**10. COA-053438-2019**

2010 West Grace Street

Commission of  
Architectural Review

STAFF REPORT

Figure 7. 2010 West Grace Street, undated photograph provided by the applicant.

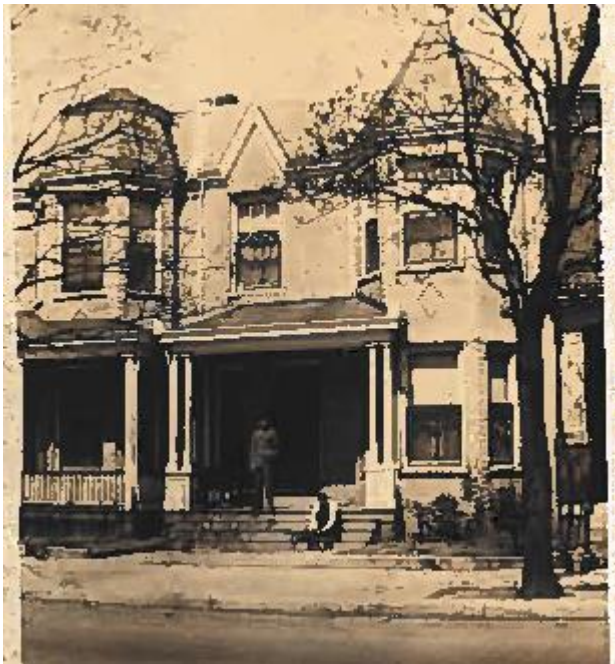
foot deep and 15'-2" wide porch. The new porch will be the same depth as the neighboring porches and a similar width. Based on the historic photographs provided by the applicant, historic Sanborn maps, and comparison to other porches on the block, staff finds the new porch is an accurate replication of the historic porch and recommends approval of the application.

Staff notes inconsistencies in the application and requests the applicant confirm the columns will be round in keeping with the historic photographs.
